## *City of El Paso – City Plan Commission Staff Report*

**Case No:** SUSU12-00007 Rio Valley Subdivision  
**Application Type:** Major Combination  
**CPC Hearing Date:** August 23, 2012

# ATTACHMENT 3

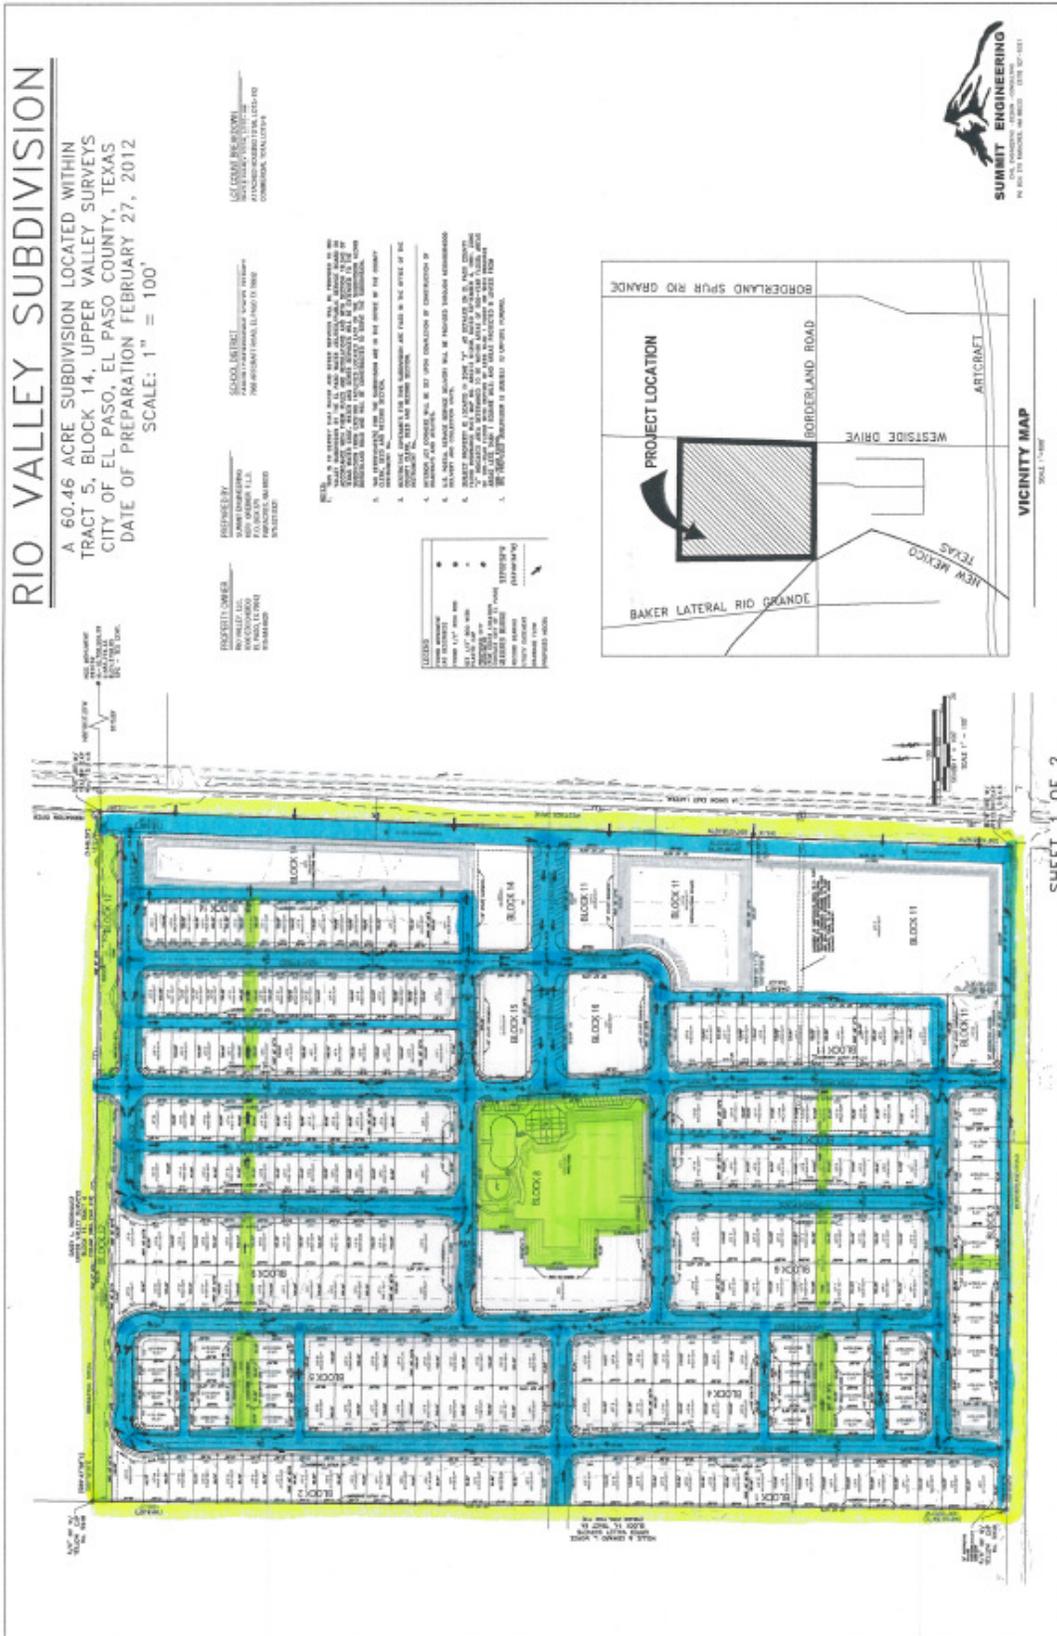
1. The Dedication Statement need to be modified, delete “ponding area” and include “park /pond”.

The 911 District requests that a NEW STREET NAME be selected where the northern most east/west street connects TAMA ST and HARAPON ST due to addressing range disparity.
